**SITE PLAN REVIEW COMMITTEE
MEETING AGENDA**

Item 1. Century Center Residential (SP #442) 7:00pm–8:30pm
(RPC # 34-020-032)
Planning Commission and County Board meetings May 2017.
Peter Schulz (CPHD Staff)

ITEM 1
Century Center New Residential
(SP #442)
(RPC # 34-020-032)
Stephen Hughes, SPRC Chair

Figure 1—Site

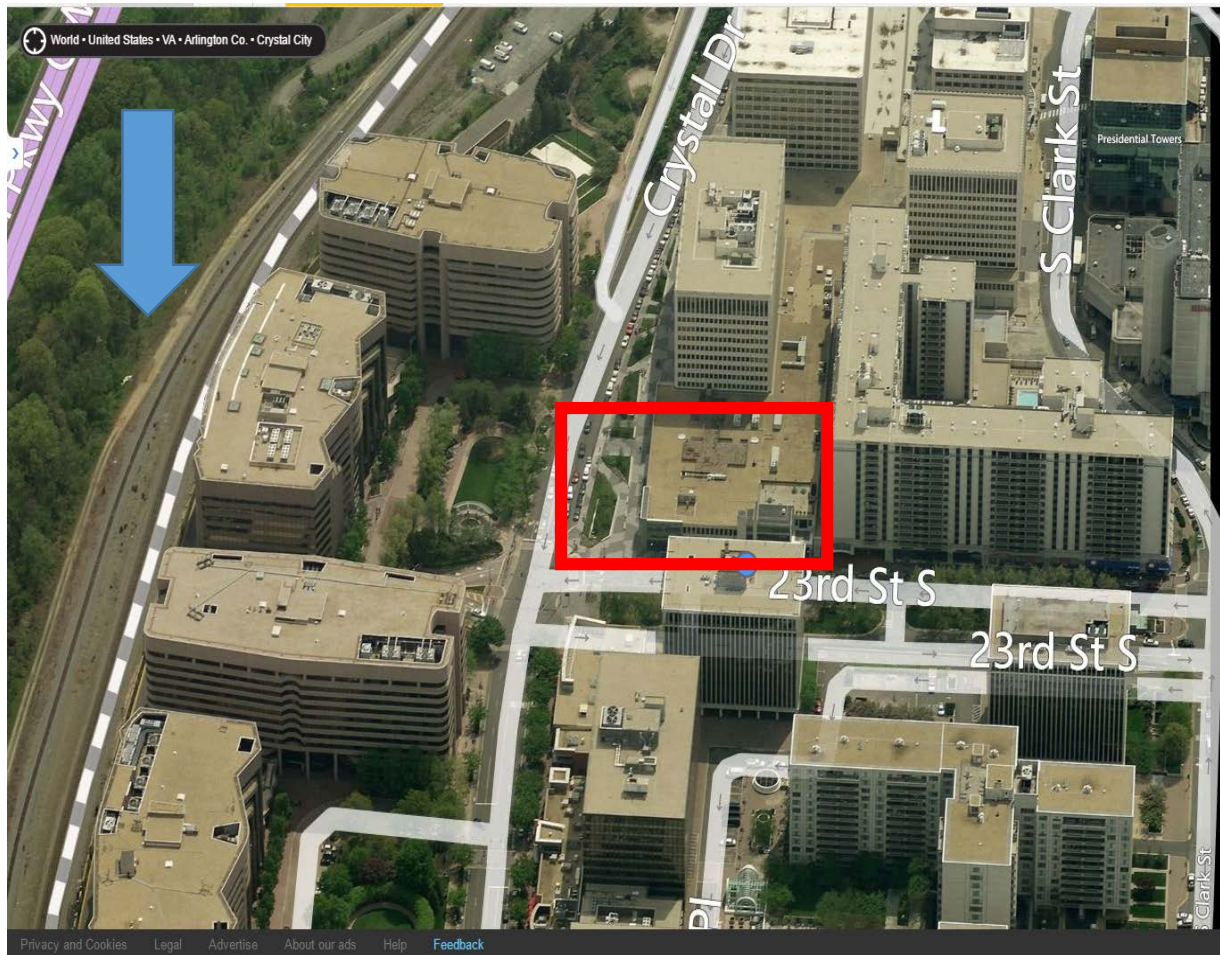
The developer proposes, instead of building to the build-to line, to keep the small pocket of open space at the southwest corner of Crystal Drive and 23rd Street, which includes mature trees. The developer has stated that they will not place the building transformers in this location as shown on the 4.1 plans, and instead will place the transformers on the roof of the second level.

Agenda Item 2.a.i. and 2.b.iii.: Developer's request to not construct to build-to line on Crystal Drive. Staff preference is for the developer to follow the Crystal City Sector Plan recommendations, perhaps with a one or two-story extension to the podium.
